Subject: LOW WASHER FLUID LEVEL WARNING LIGHT COMES ON WITH WASHER FLUID IN THE TANK	Service Alert No.: SA-061/24
	Last Issued : 09/25/2024

2025 CX-70
2024-2025 CX-90

Reference the Owner's Manual -
Replenishing Windscreen Washer Fluid

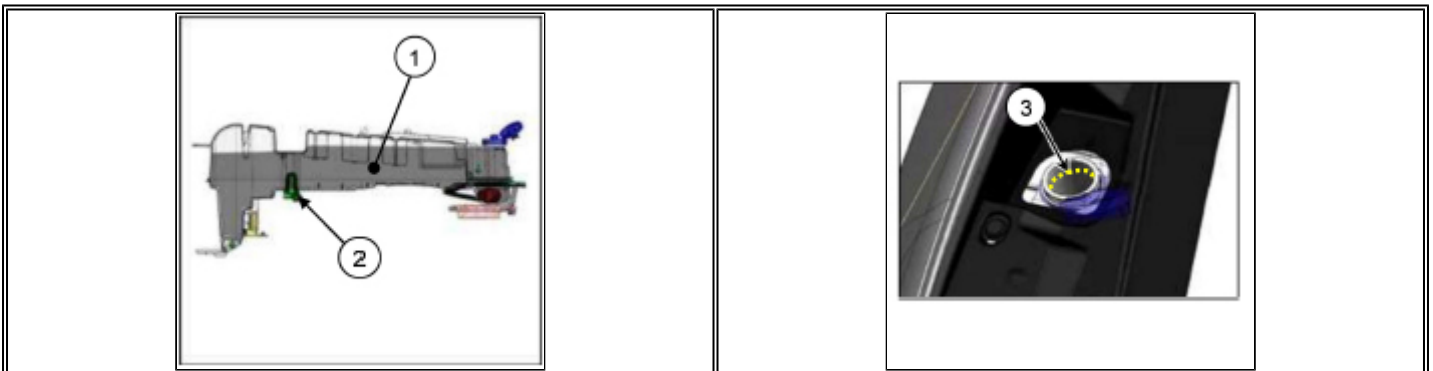
NOTE: The shape of the washer fluid tank cap has been changed from a pop-up type to a rotating type. When replenishing the washer fluid, **DO NOT** open the cap by pulling it, as it may be damaged. Open the cap by rotating it 90 degrees counterclockwise, as shown in the following figures.
